**SUBMITTAL TO THE BOARD OF SUPERVISORS
COUNTY OF RIVERSIDE, STATE OF CALIFORNIA**

SUBJECT: Adopt Resolution No. 2015-025 Revising the Special Flood Hazard Areas in the Public Flood Hazard Determination Interactive Map Pursuant to Ordinance No. 458; CEQA Finding of Exemption; District 3

2
3 RESOLUTION NO. 2015-025

EXHIBIT "B"

EXHIBIT A

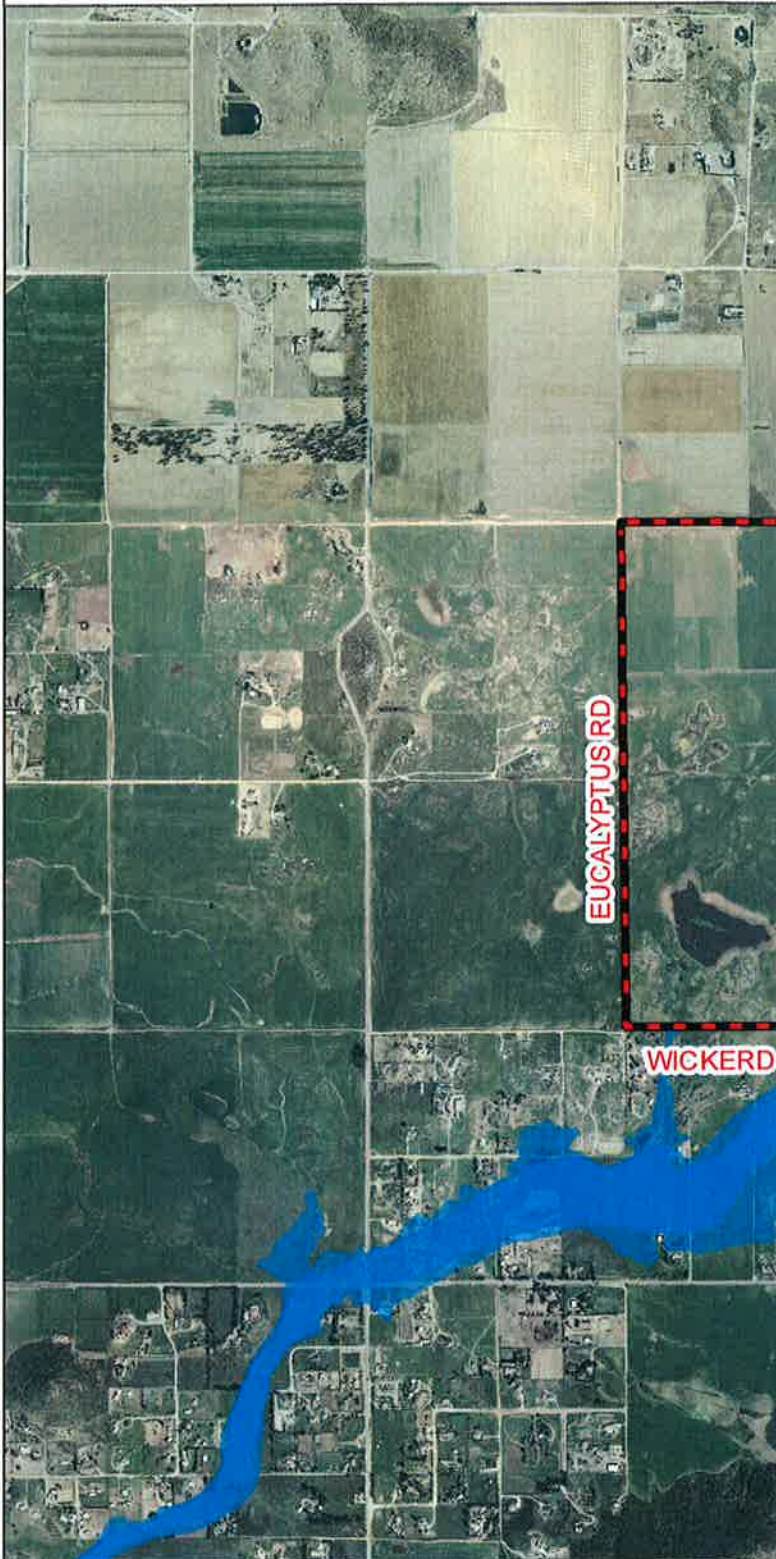
- 15 3. Revising the Special Flood Hazard Areas in the Public Flood Hazard Determination
16 Interactive Map is hereby authorized and the floodplain limits shown in red on attached
17 Exhibit "A" shall be deleted.

Therefore, the special flood Hazard Areas along Warm Springs Creek and the unnamed tributary shown in red on the attached exhibit shall be revised and removed from the Public Flood Hazard Determination Interactive Map.

The attached exhibit, SP310 Floodplain Removal shows the limits of the current floodplain and the portions to be removed. The unnamed tributary floodplain shown on the southern portion of the exhibit should be deleted upstream (east) of Washington Road deleted. The Warm Springs Creek floodplain shown on the northern portion of the exhibit should be deleted upstream (north) of Wickerd Road removed.
